15th August 2017

SERVICE BULLETIN 147 - REPLACING THE SIDE AND REAR FLYING WIRES ON A GT450 (V1.21)

Fig 2: Note there is only one FW4-12 washer and that there are no washers between the cable thimbles and the tubing. Note also the upper rigging wire is fitted in the outer most rear position.

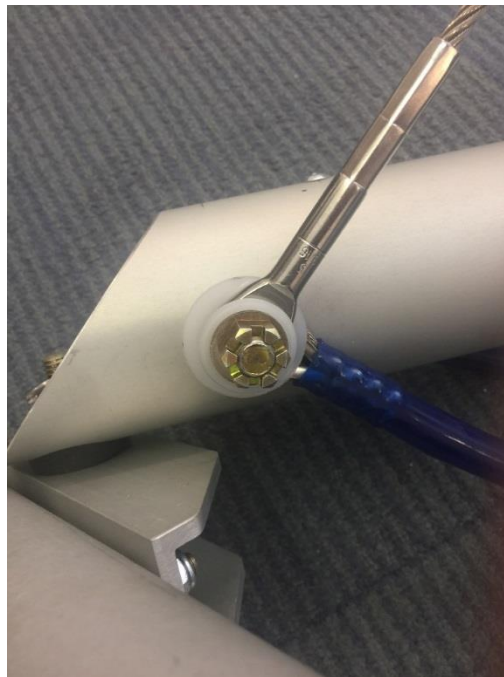
As part of SB 147, we have taken the opportunity to embody approved Modification 247 which replaces a number of the plated mild steel washers with nylon washers (Part Number FWP-002) in order to reduce localised corrosion issues. This is feasible as the bolts are shear loaded rather than tensile loaded here.
